**City of McMinnville**  
**Planning Department**  
231 NE Fifth Street  
McMinnville, OR 97128  
(503) 434-7311

## **EXHIBIT 3 - STAFF REPORT**

**DATE:** December 28, 2018  
**TO:** Historic Landmarks Committee Members  
**FROM:** Chuck Darnell, Senior Planner  
**SUBJECT:** HL 5-18 / DDR 4-18 – Alteration and Downtown Design Review Requests - 711 NE 3<sup>rd</sup> Street

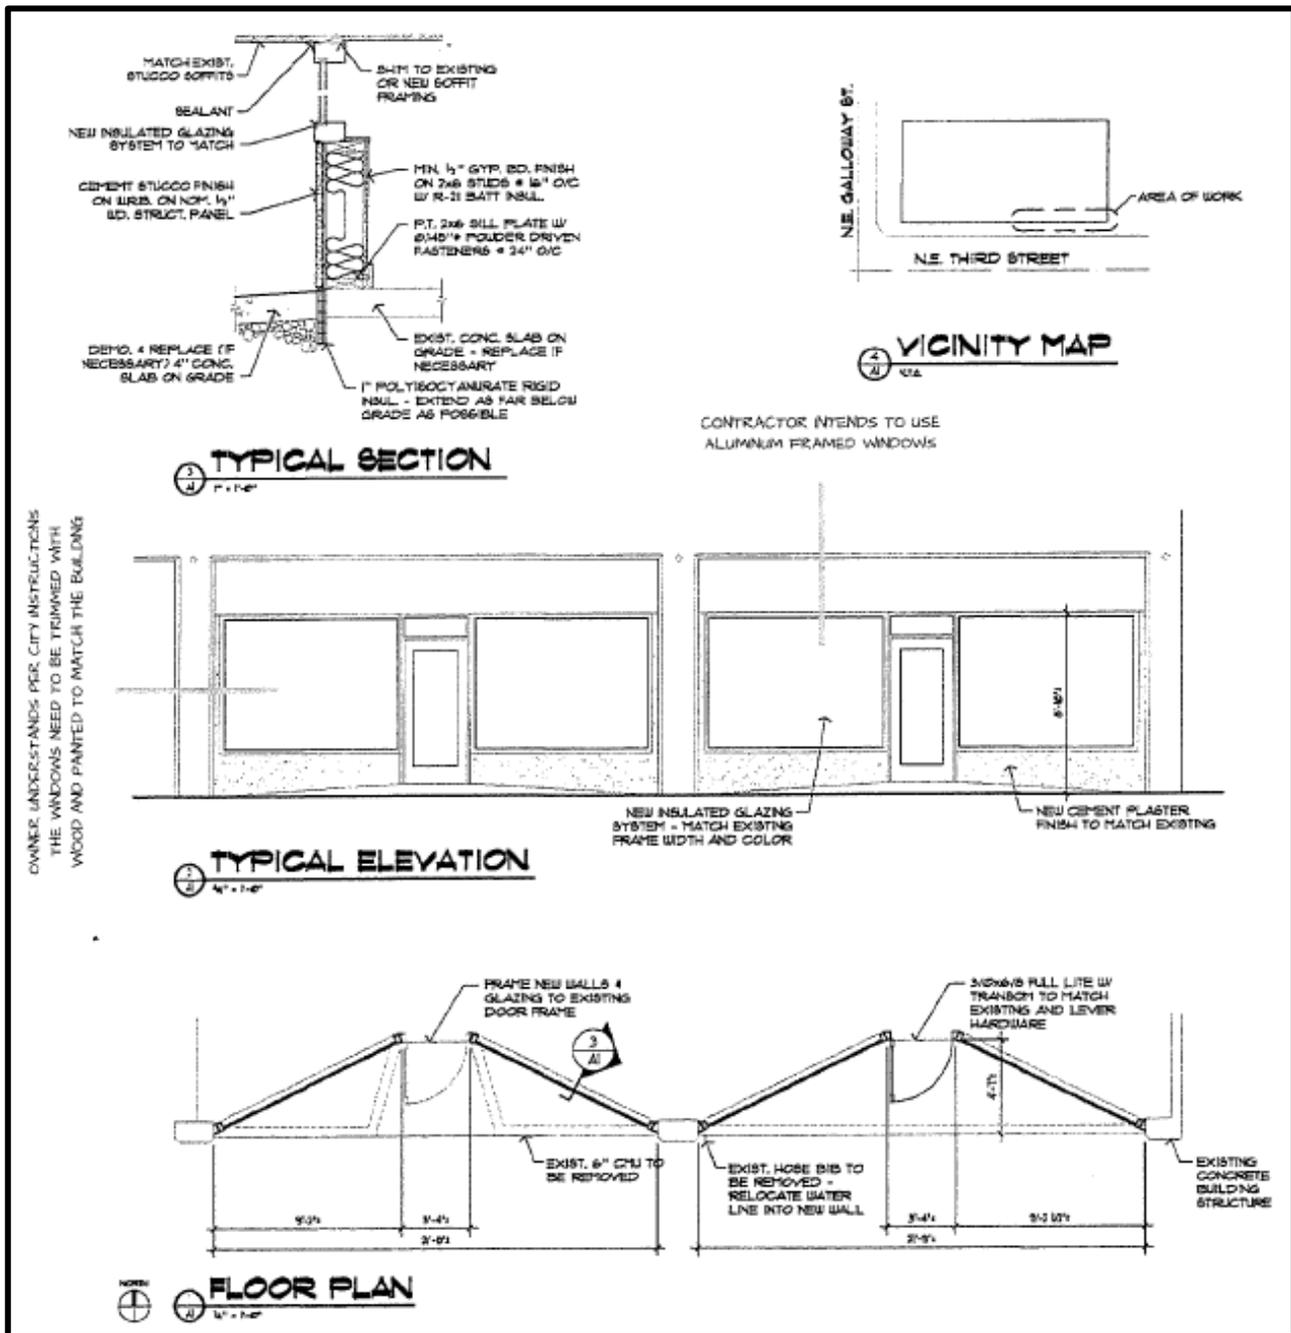
The applicant is proposing to remove an existing concrete block wall on the two easternmost bays of the Third Street ground floor façade and construct in its place two sets of recessed storefront window systems and entries. More specifically, the applicant is proposing to complete the following work on the building:

- Removal of the front façade concrete block wall that was constructed in the 1960's across a portion of the Douglas Hotel building.
- Rehabilitation of two storefront bays to include creation of inset storefront entries with angled windows and a centered front entry door for each storefront. The two sets of front entries are proposed to each be located between the vertical stuccoed cement clad columns that provide rhythmic spacing along the face of this building. An existing example of this building design is seen along the front of the western portion of the Thai Country Restaurant which currently occupies commercial space within the building.

Staff agrees that the ground floor façade on the two bays proposed to be altered have been heavily altered over time, and that the existing features and materials are not historic. The rehabilitation of the two bays with two new storefront window systems with recessed entries is visually compatible with the historic building.

In terms of the specific materials proposed, the Historic Landmarks Committee must determine whether the proposed aluminum storefront windows are physically and visually compatible with the existing historic materials and features of the building. The applicant is proposing the aluminum windows in order for the bays to be consistent with the other aluminum storefront window systems that exist in the other bays on the ground floor of the building, and has also provided arguments for how aluminum storefront windows may have been in use during certain periods in the past. However, there is no evidence that the existing aluminum windows were historic materials that existed on the building during its initial period of construction, which is what led to the building being classified as a Secondary Significant Contributing resource in the Downtown Historic District. The dates of construction for buildings classified in the historic district as Secondary Significant Contributing resources was 1913-1937. The statement of historical significance and description of the property, as described in the nomination of the Downtown Historic District, states that most, if not all, other windows besides the aluminum framed storefront window systems were wood. These include windows that were described as follows: “second floor windows are one over one double-hung wood sash”; “a series of three fixed six-light wood frame windows... located at mezzanine level on the south façade”; “north of the cut away storefront is a bay containing three wood fixed six-light windows”; and “next bay to the north contains a wood frame plate glass window and door”.

1. That the storefront windows be wood framed windows, or that wood trim and sills be applied to the exterior of the internal aluminum framed windows.
2. That the applicant shall submit building permit applications prior to completing any work, and that the construction plans submitted with the building permit applications shall be consistent with the exhibits, drawings, and renderings submitted for review by the Historic Landmarks Committee, and consistent with all applicable conditions of approval.

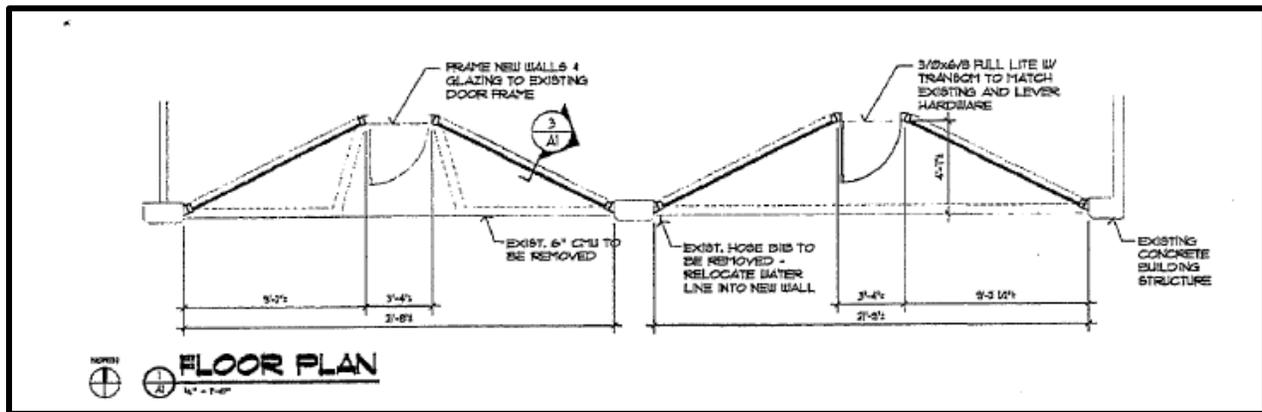
The proposed design includes recessed entries, which open onto the public right-of-way. The floor plan of the recessed entries can be seen below:

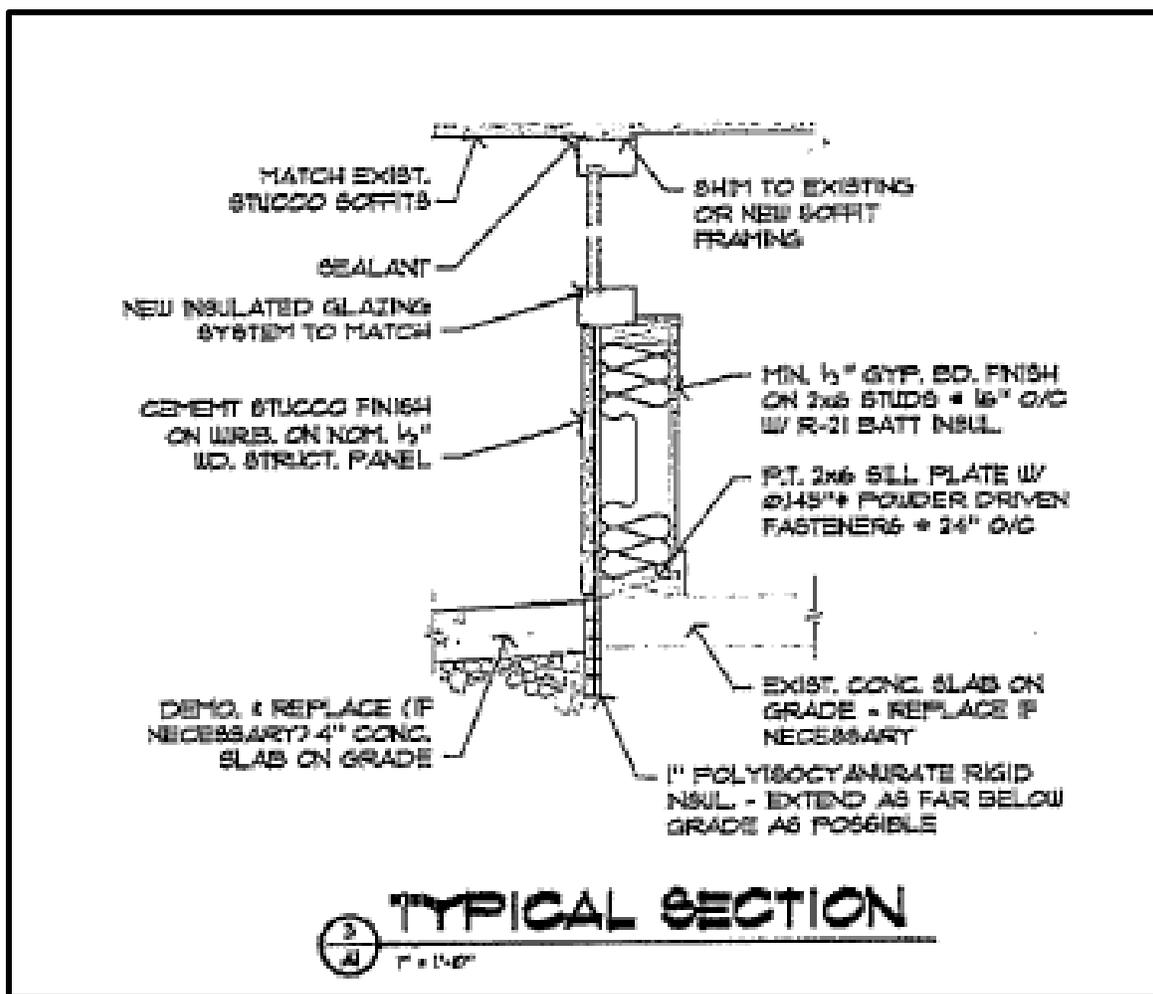
6. Windows shall be recessed and not flush or project from the surface of the outer wall. In addition, upper floor window orientation primarily shall be vertical.

The windows are proposed to be recessed by from the outer wall and above the bulkhead beneath the windows. The recessed windows are shown in the section below:

1. That the storefront windows be wood framed windows, or that wood trim and sills be applied to the exterior of the internal aluminum framed windows.
2. That the applicant shall submit building permit applications prior to completing any work, and that the construction plans submitted with the building permit applications shall be consistent with the exhibits, drawings, and renderings submitted for review by the Historic Landmarks Committee, and consistent with all applicable conditions of approval.
3. Any future signage proposal shall be submitted to the Planning Department for review and approval by the Planning Director or Historic Landmarks Committee, depending on whether the signage constitutes a major or minor alteration to the site, prior to installation. It shall be the Planning Director's decision as to whether the signage proposed is a major or minor alteration.
